Universal Jeans-3

Plot # 69, Sector # 7, Export Processing Zone, Chattogram -4223
(22.300516, 91.776743)
17th February 2021

Observations

Figure 2.1.2: 3D View of Analytical Model

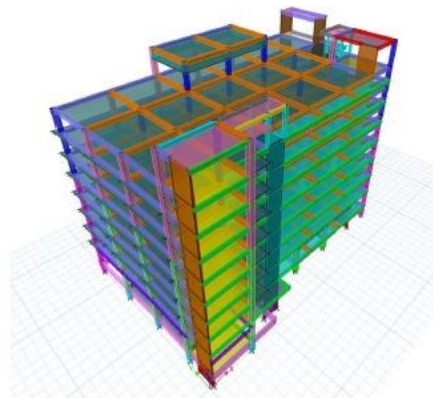
A Design Report was provided for the Main Building at the time of inspection which is prepared based on software analysis. But no software analysis (FEA) model was provided to review the Design report. Moreover, serviceability checks as per BNBC were not provided in the design report.

Item No.	Observation	Recommended Action Plan	Recommended Timeline
01	Information missing in the design report.	Building engineer is required to check the serviceability issues as per BNBC and incorporate proper loading assignment in the design report.	6-weeks
02	Information missing in the design report.	Building engineer is required to provide slab adequacy check for 6 kPa live load.	6-weeks
03	Information missing in the design report.	Building engineer is required to provide detail pile capacity calculation.	6-weeks
04	Information missing in the design report.	Complete implementation of any remedial works deemed necessary by the design report.	6-months
05	Columns susceptible to impact loading.	Construct and maintain protection to critical column and continue to assess likelihood of vehicle impact to critical elements.	6-weeks

Figure: First Floor Slab Check

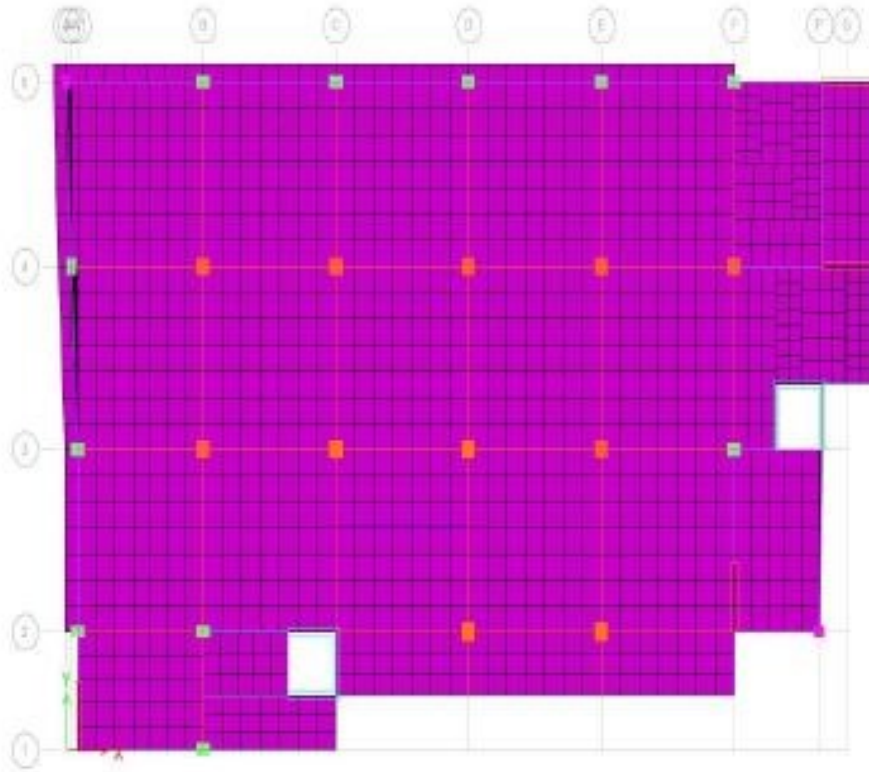
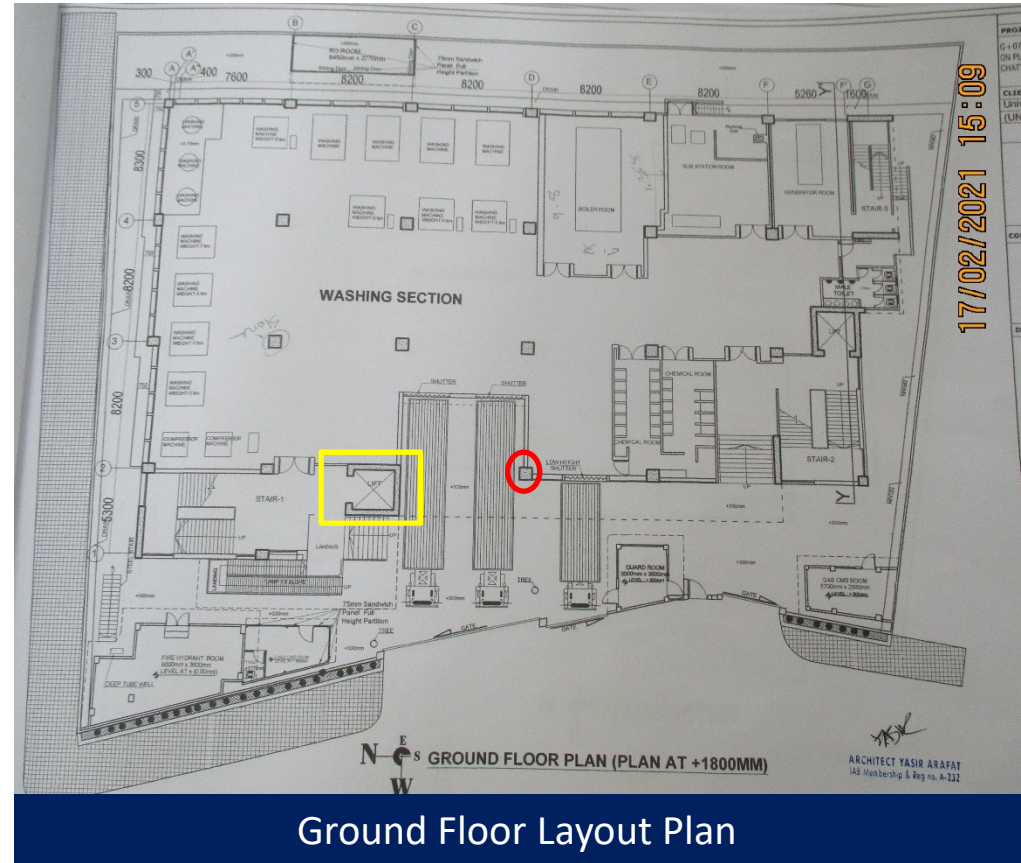
Slab adequacy check not provided in the design report. Building engineer is required to provide slab adequacy check for 6 kPa live load.

Figure 3.3.1: 3D View of Analytical Model

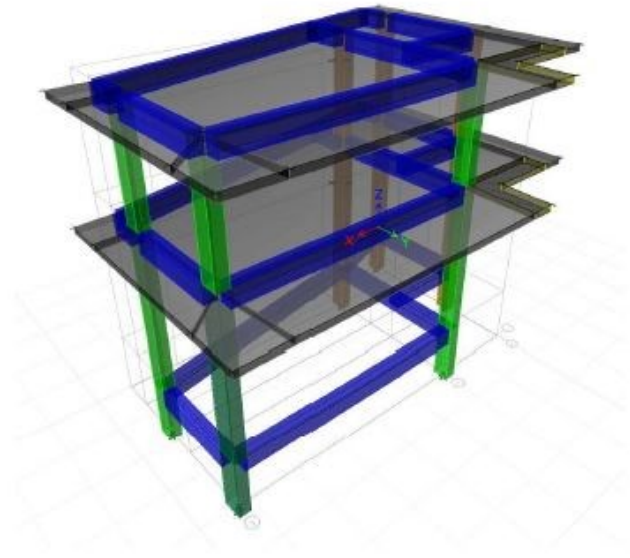
A Design Report was provided for the Fire Control Room and Pump House at the time of inspection which is prepared based on software analysis. However, no software analysis (FEA) model was provided to review the Design report. Factory is required to submit the full set of Design Report with software-based analysis model for review.

Item No.	Observation	Recommended Action Plan	Recommended Timeline
06	Incomplete Design Report.	Factory is required to submit the design report with analysis model for review.	6-weeks
07	Incomplete Design Report.	Provide necessary calculation/explanation (with reference) regarding the eccentric loading on the footing and make sure the center of column and center of footing coincide.	6-weeks
08	Incomplete Design Report.	Carry out remedial works where necessary.	6-months
09	Non engineered external steel stair.	Factory engineer is required to carry out connection adequacy & lateral stability check of the steel stair.	6-weeks
10	Non engineered external steel stair.	Implement remediation work where necessary.	6-months

Footing Layout

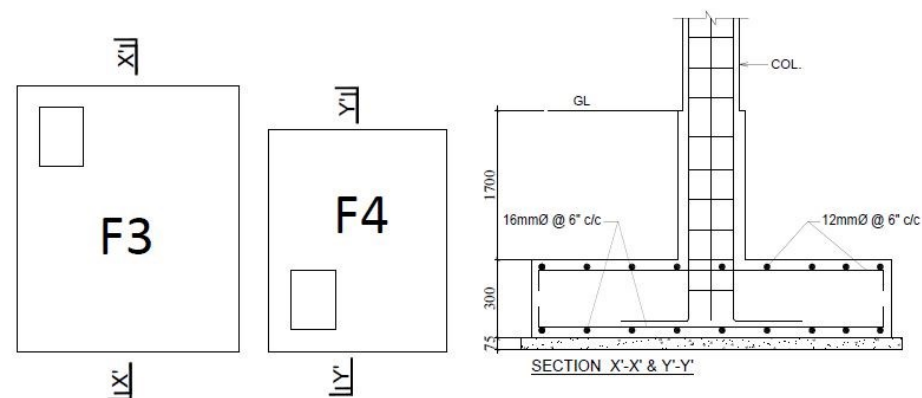
As per provided structure drawings few columns are found eccentric with the isolated footing. Building engineer is to provide necessary calculation regarding the eccentric loading on the footing and make sure the center of column and center of footing coincide.
